**DOCUMENT 00 90 00  
ADDENDUM**

**ADDENDUM NO. [4]                      Date: November 21, 2018**

**RE:                      GLENWOOD COMMUNITY SCHOOL DISTRICT  
ATHLETIC COMPLEX IMPROVEMENTS BID PACKAGE 2 REBID  
400 SIVERS ROAD  
GLENWOOD, IOWA 51534  
HSR PROJECT NO. 18005**

**FROM:                  HSR Associates, Inc  
100 Milwaukee Street  
La Crosse, WI 54603  
(608) 784-1830**

**P100R**

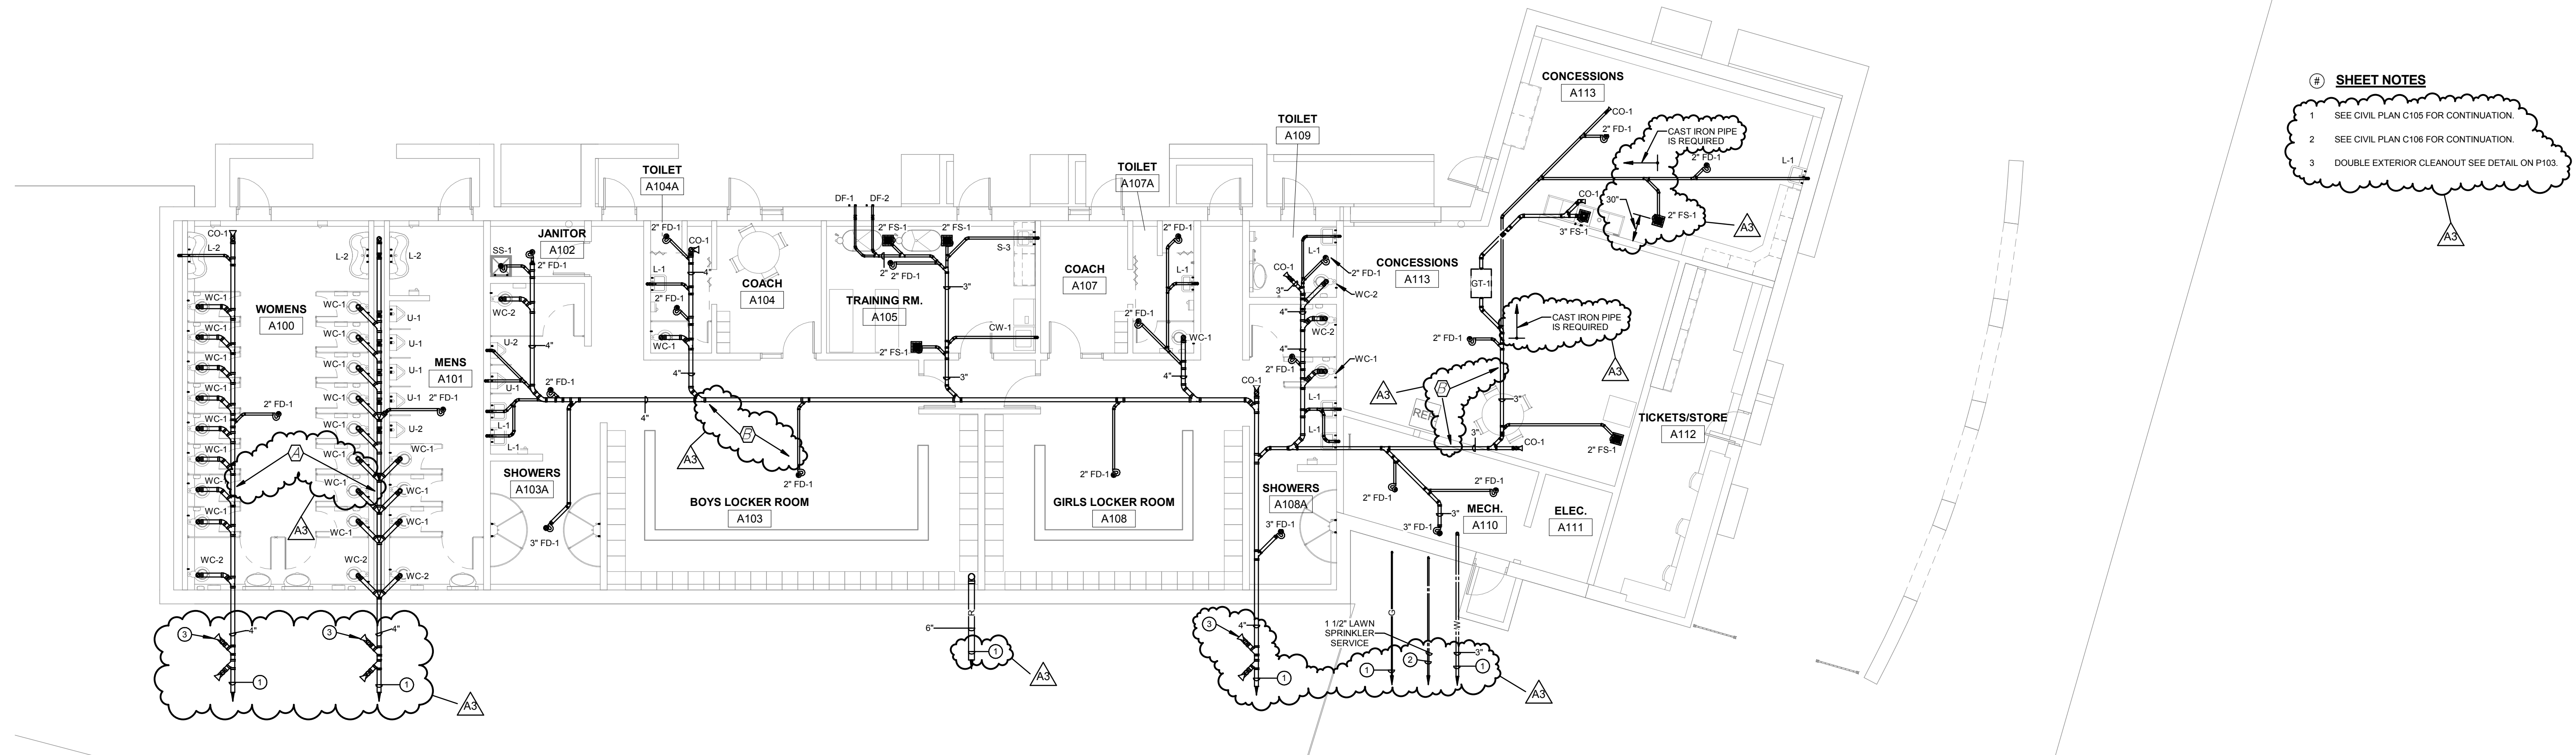
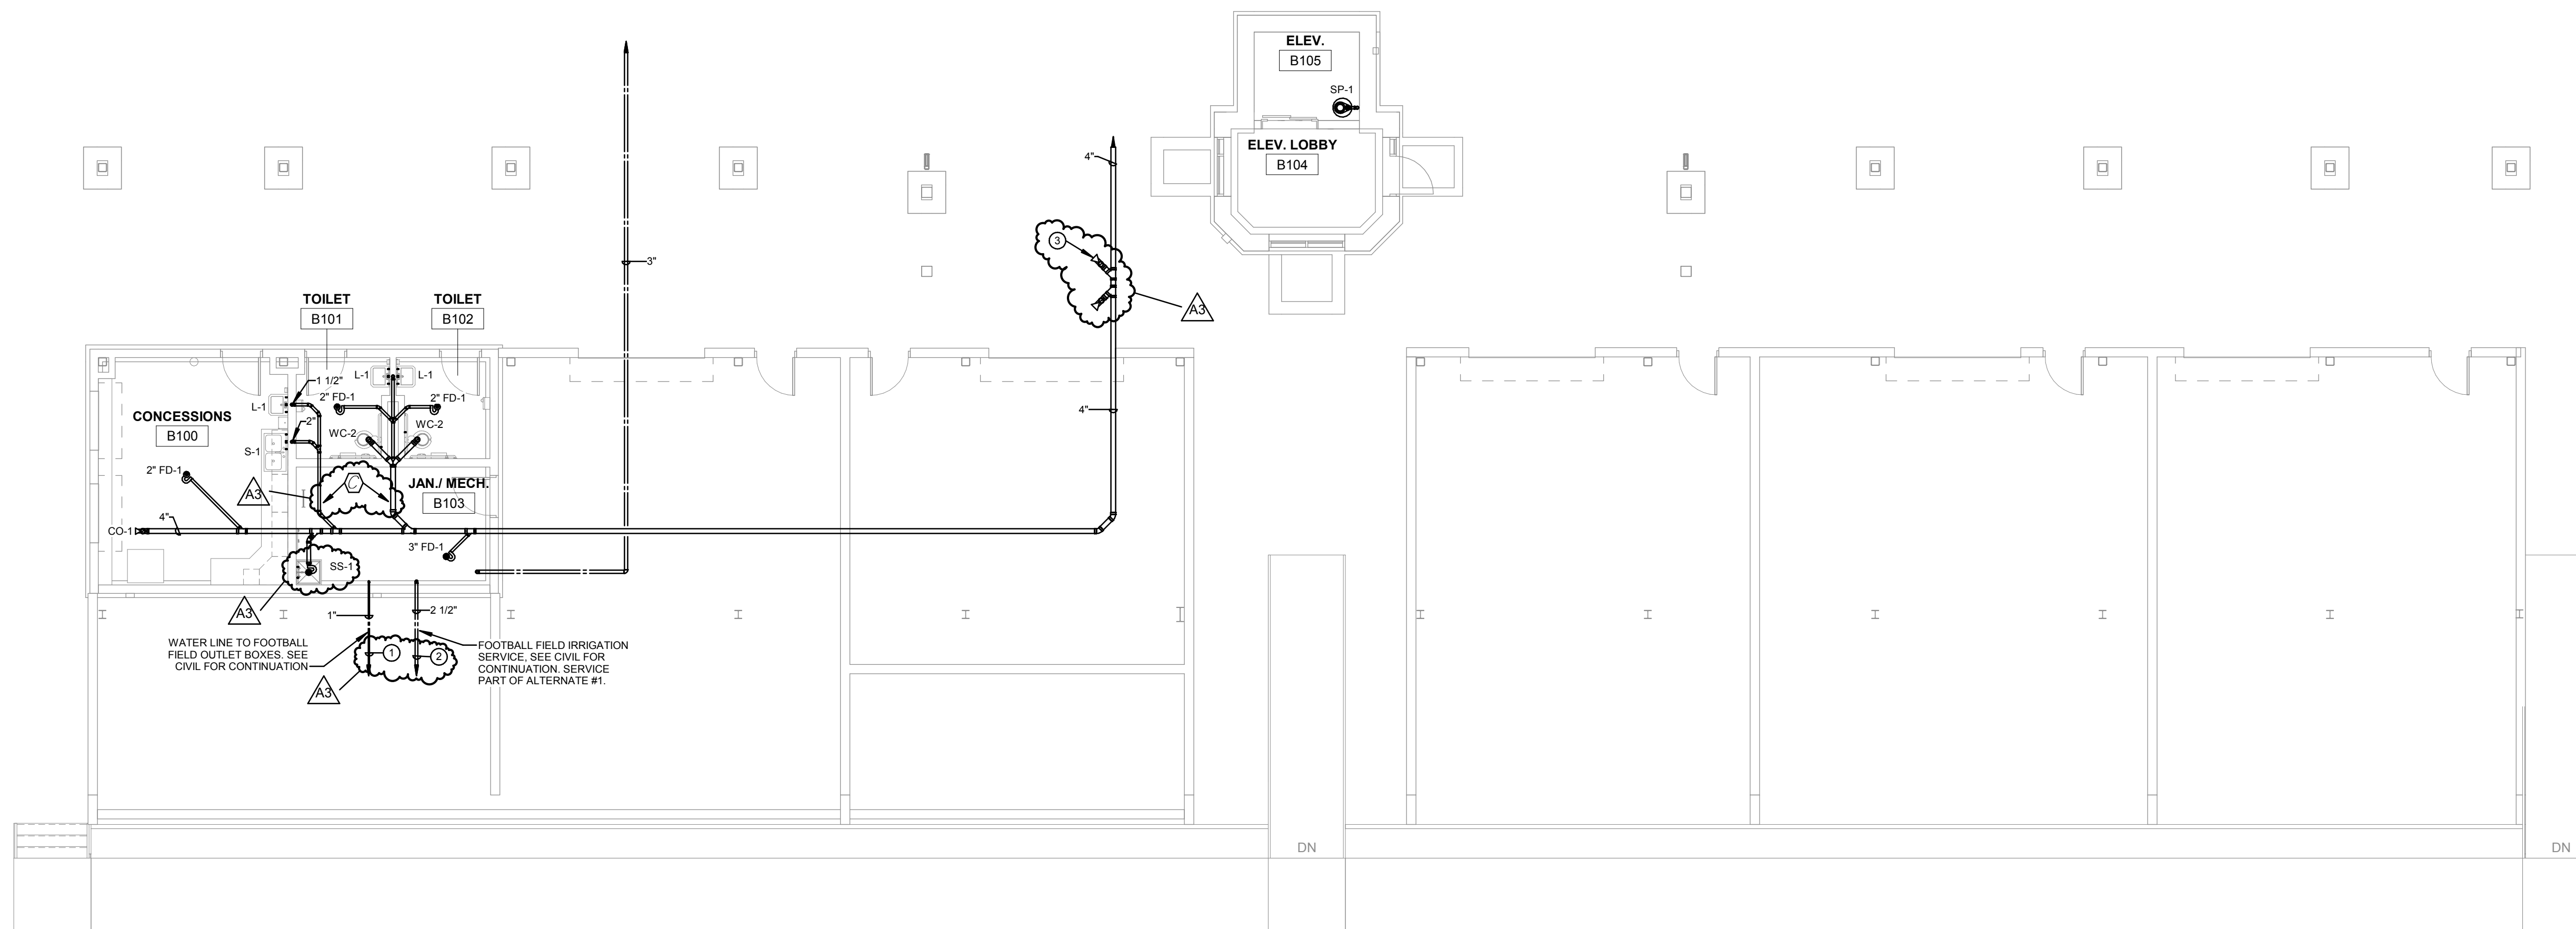
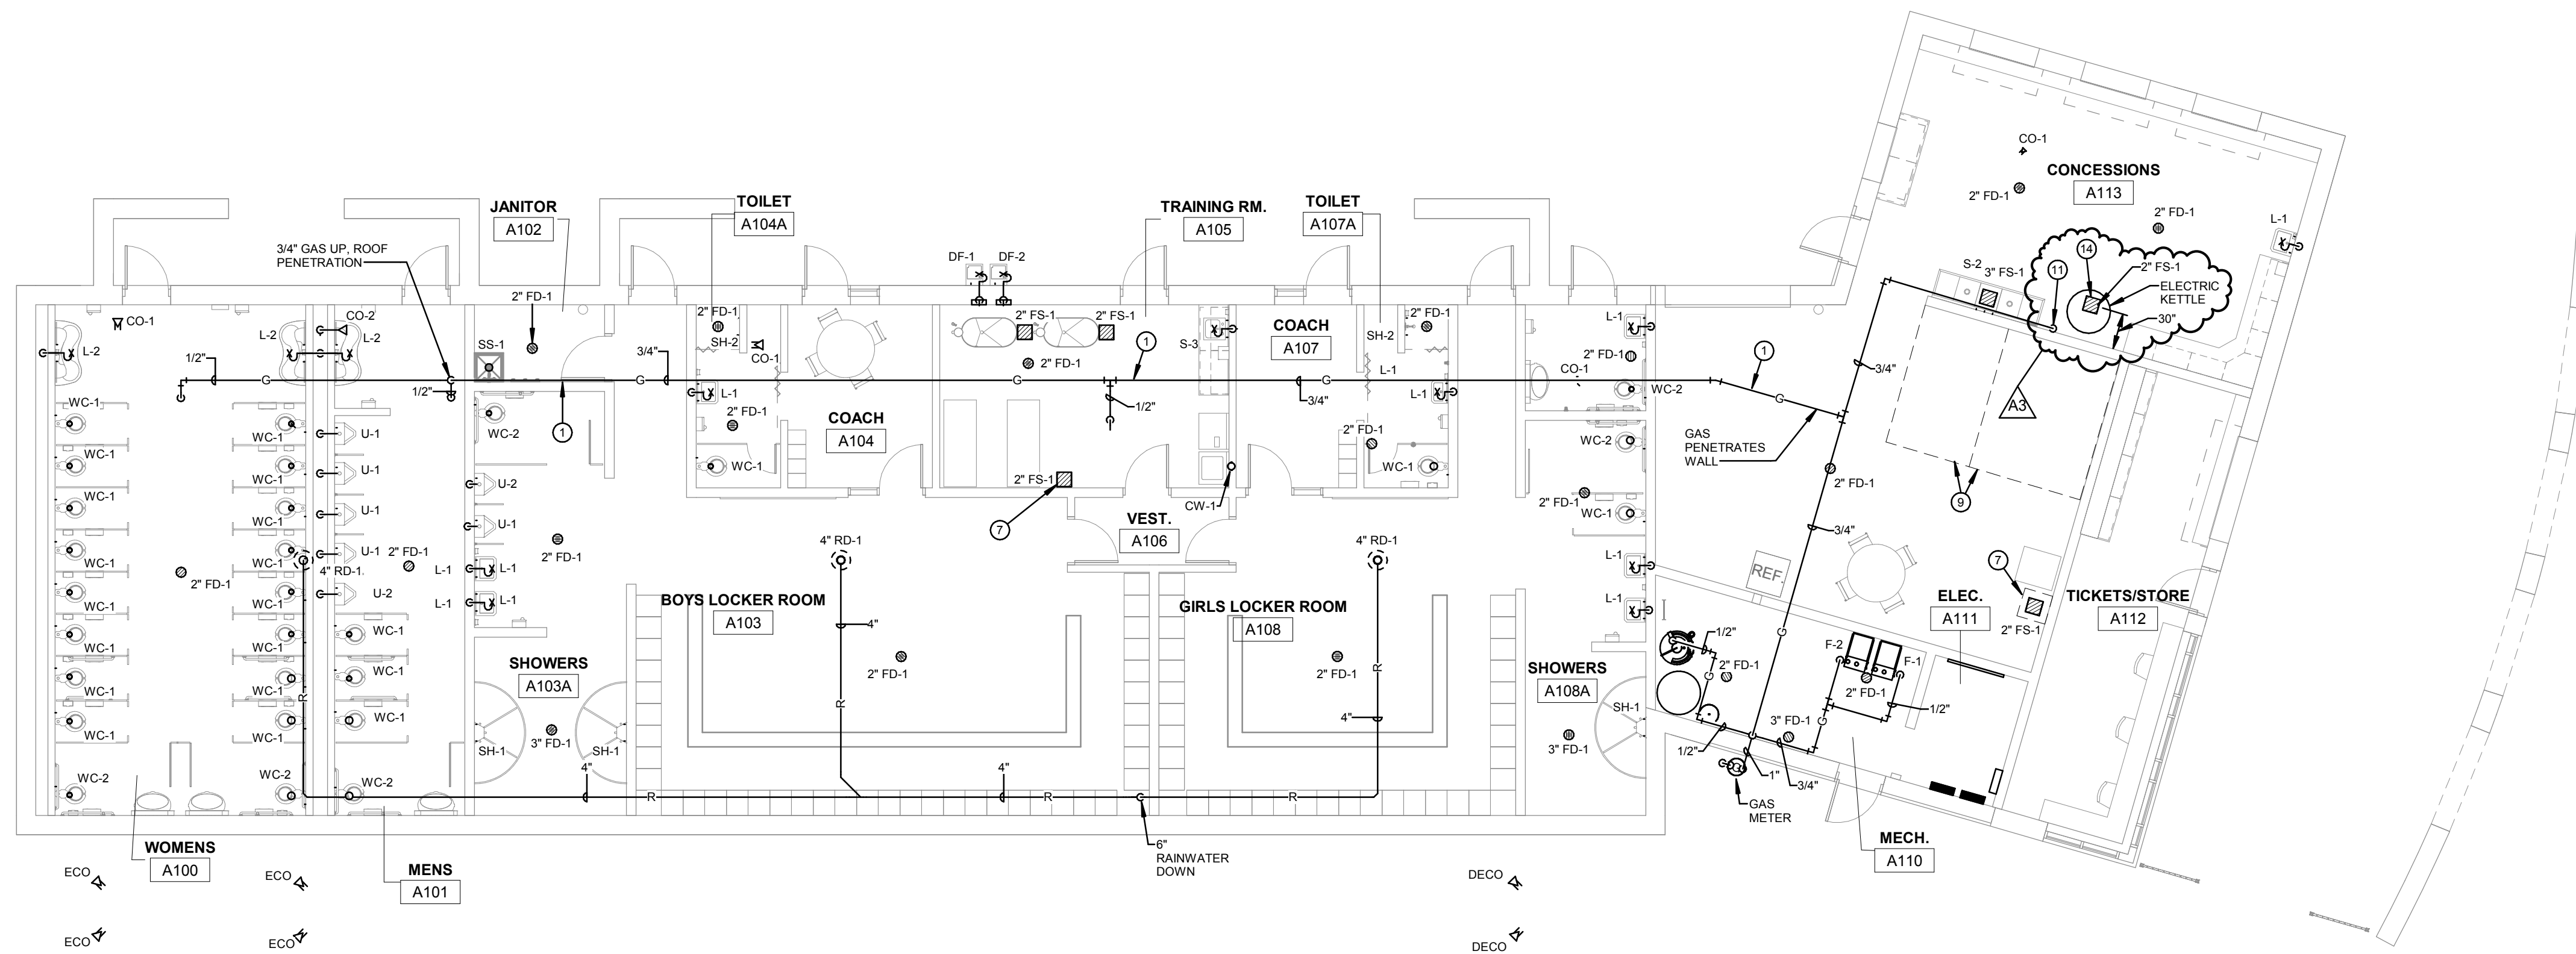
1. The following drawings were referenced by text in addendum 3 but not attached to the addendum.
2. Sheet P100R GATEWAY & STADIUM UNDERFLOOR PLUMBING PLANS 30 x 42 attached hereto.

- a. Revisions clouded on Drawing.
  - b. Double exterior cleanouts on sanitary pipe 5'-0" away leaving the building. See detail on sheet P103
  - c. Added Notes #1, #2 and #3 to see civil plans for continuation and exterior cleanout detail.

- d. Added plumbing riser designations to cross reference Underfloor Plumbing Plans to the Plumbing Risers on P104.
  - e. Add note for location of cast iron pipe in Concessions A113.
